Addendum No. 1

RE: Contract # C205036

Robeson County (U-5797)

SR-1997 (FAYETTEVILLE RD) FROM FARRINGDOM ST TO EAST 22ND ST

1/22/2026
F:\Utilities\Engineering\UC\Proj\Sheet\U5797_ut.uc.pfl_psh16.dgn
JumoreH

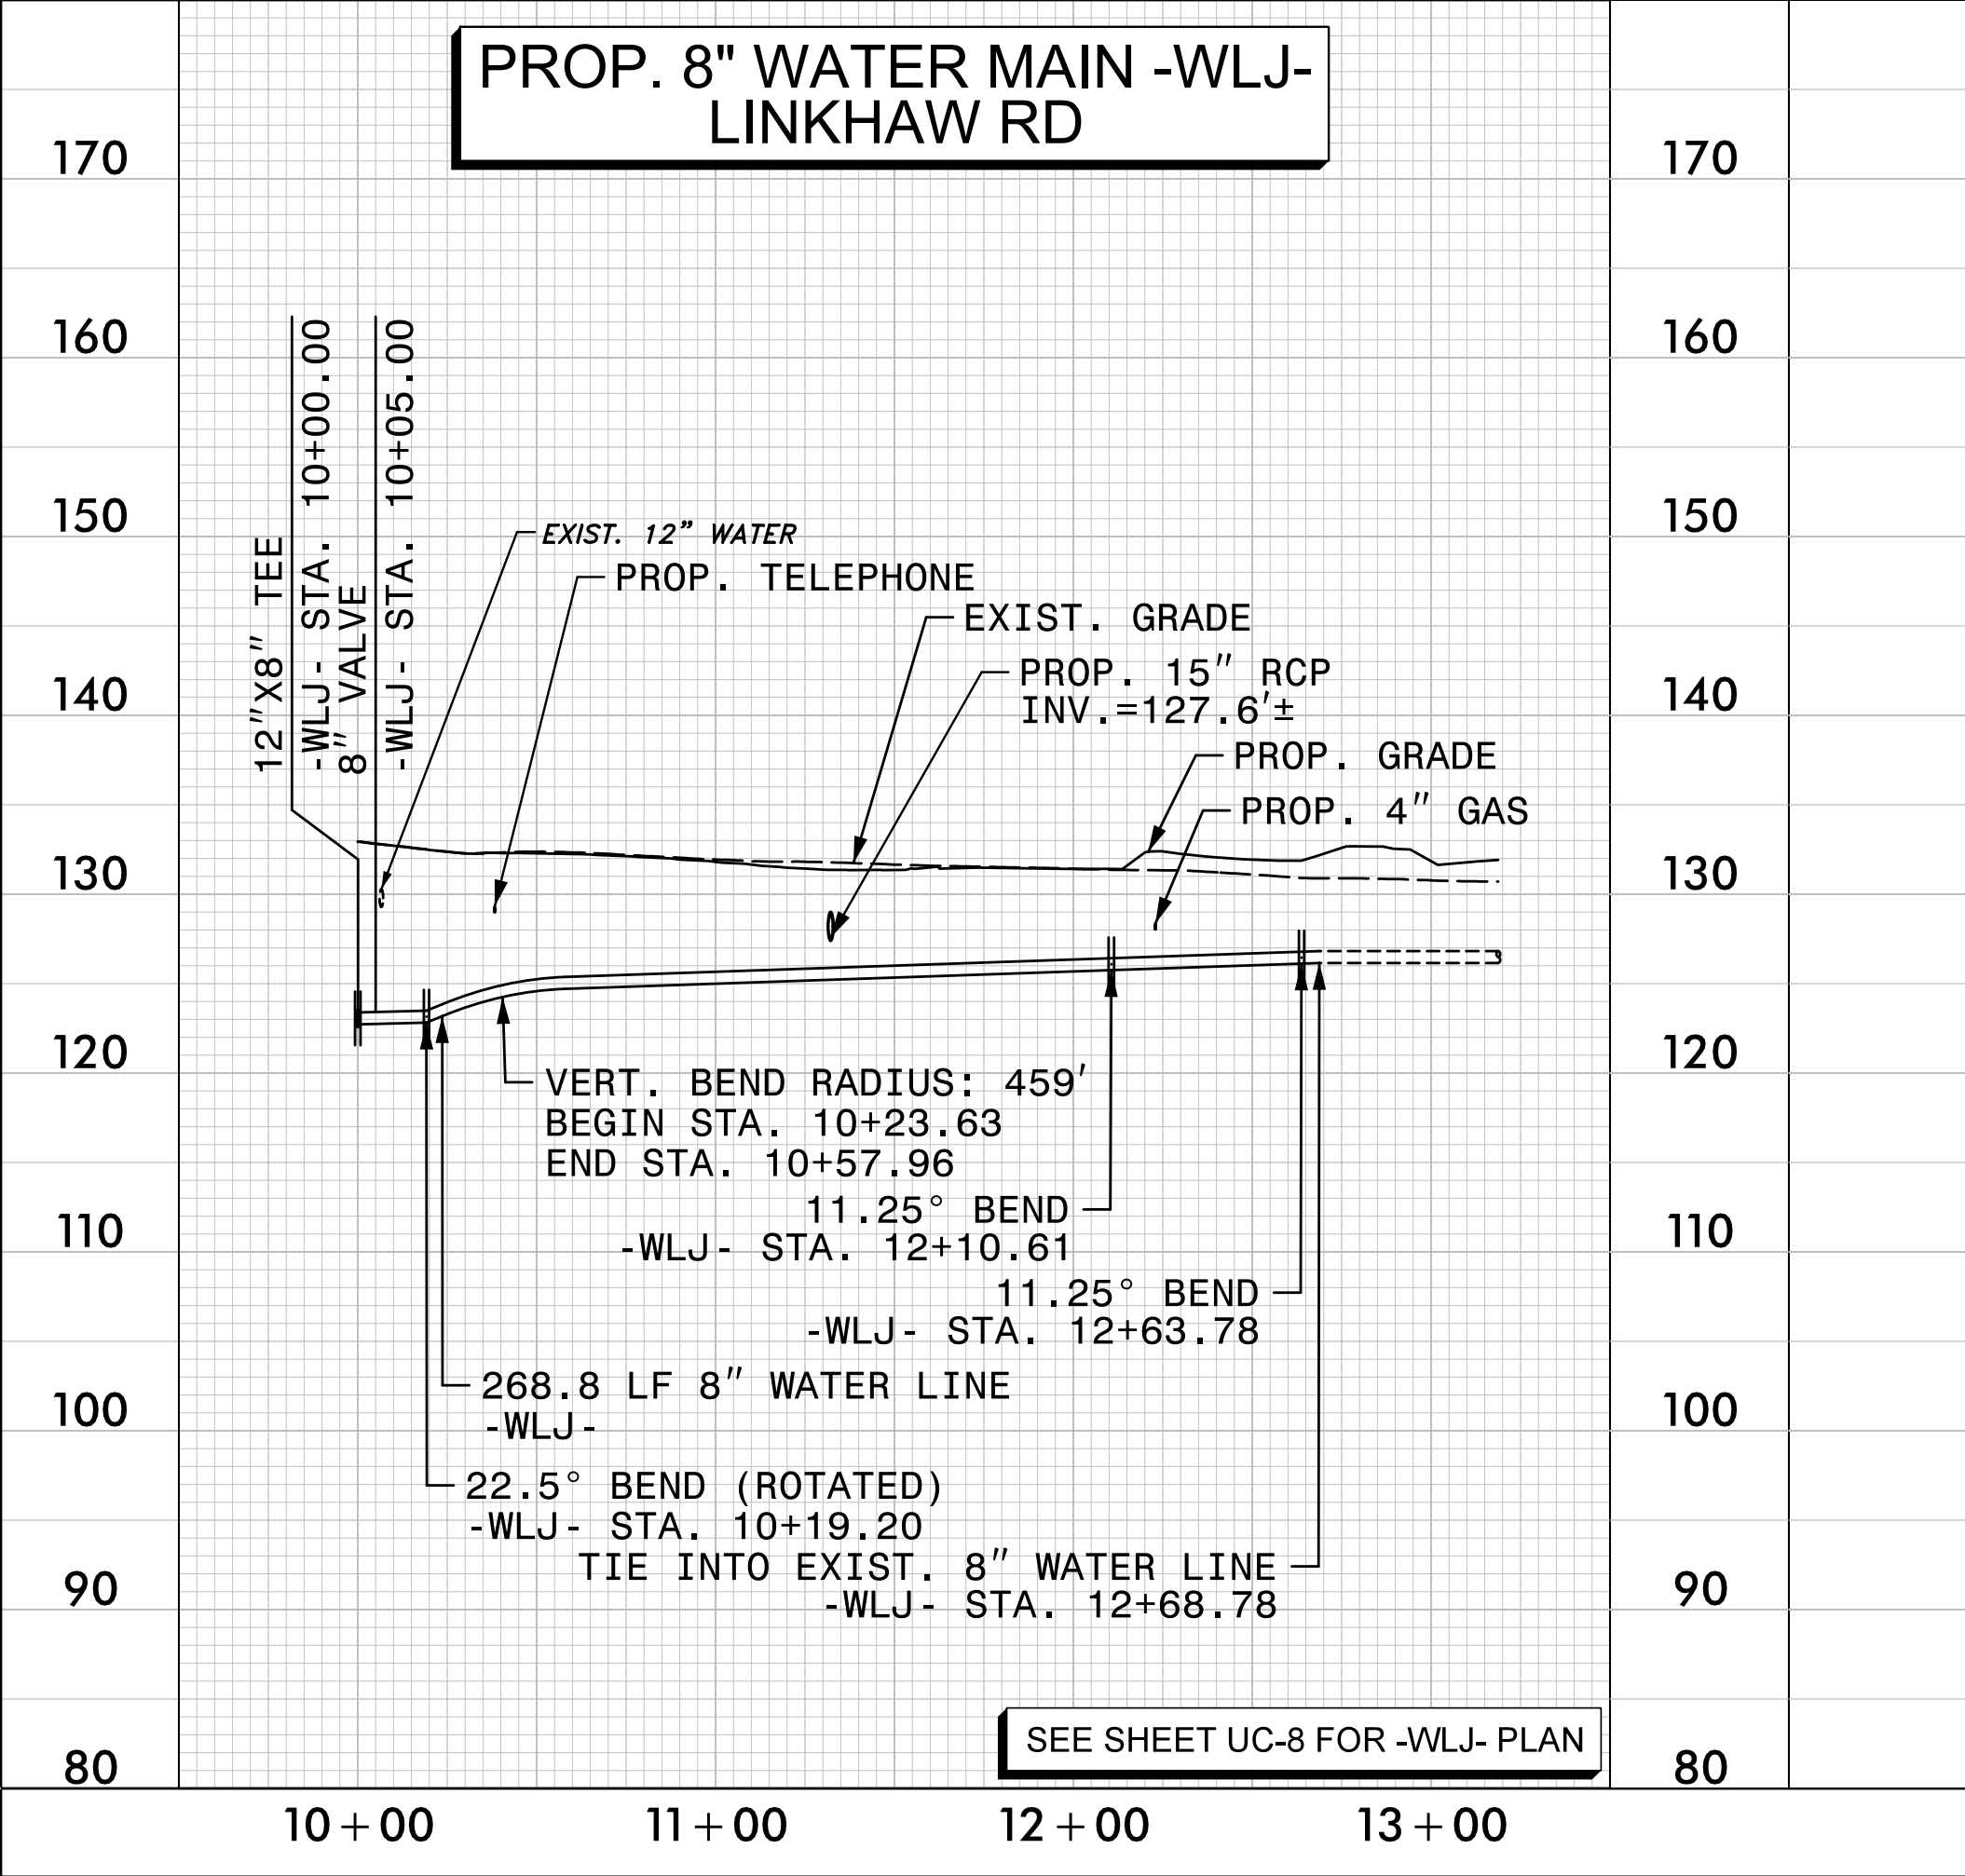
Sheet No.	Revision
UC-11	- Removed the design of waterline K around 97ft of 12in WL - Removed pipe DI water pipe fittings (2 - 450 bends, 1- 22.50 bend and 2 – 11.250 bends) - Removed 2 -12inch insertion valves - Removed 1- reconnect water meter - Removed a 97ft of 12in utility pipe that was meant to be abandoned
UC-16	Removed profile of waterline K (referenced out)
